V-83  
(2017)

## BOUNDARY SURVEY FOR JOE & MARCIA LAIN

**TYPE OF VARIANCE:** 1) Waive side setback for an accessory structure over 650 sq. ft. (proposed approximately 828 sq. ft. detached garage) from the required 100 feet to three (3) feet adjacent to the west property line; and 2) waive the side setback from the required 10 feet to 7.5 feet (existing) adjacent to the east property line.

**COMMENTS**

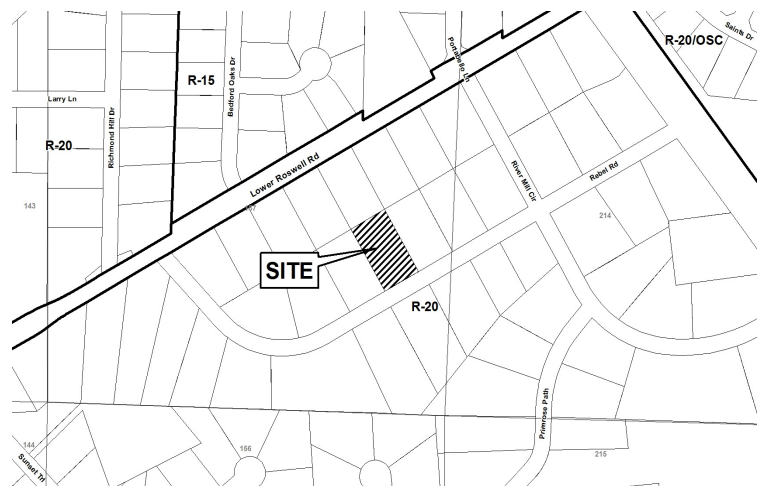
**DEVELOPMENT & INSPECTIONS:** Permit required. Footing and slab inspection required. Wall closer than 5 feet requires one hour fire rating.

**STORMWATER MANAGEMENT:** No adverse stormwater impacts are anticipated. The proposed carport will be located over an existing concrete pad.
